# Access Compliance Report

## Public Rights-of-Way

Intersection ID: 45785	Main Street: SUGARBUSH_DR	Cross Street: LONG_HILL_DR	Location:	N
ADA ID: 42E209E90B6F	Ramp Type: BlendTrans1	Initial Pass/Fail: Pass	Overall Compliance: No	Severity Score: 2.5
Codes/Mitigation Info/Possible Solution		Field Measurements/Component Compliance

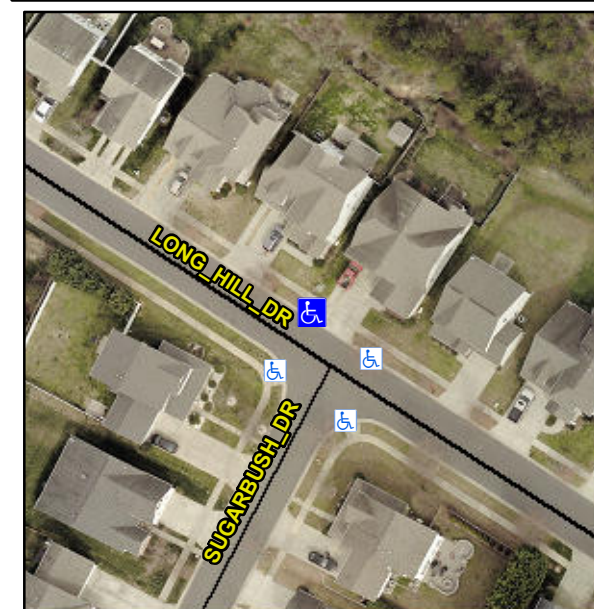
**Not Found, R304.2.2-Perp, R304.3.2-Para, R305.1.4, R305.2**

**Remove & Replace Curb Ramp With Two New Directional Ramps or Equivalent.**
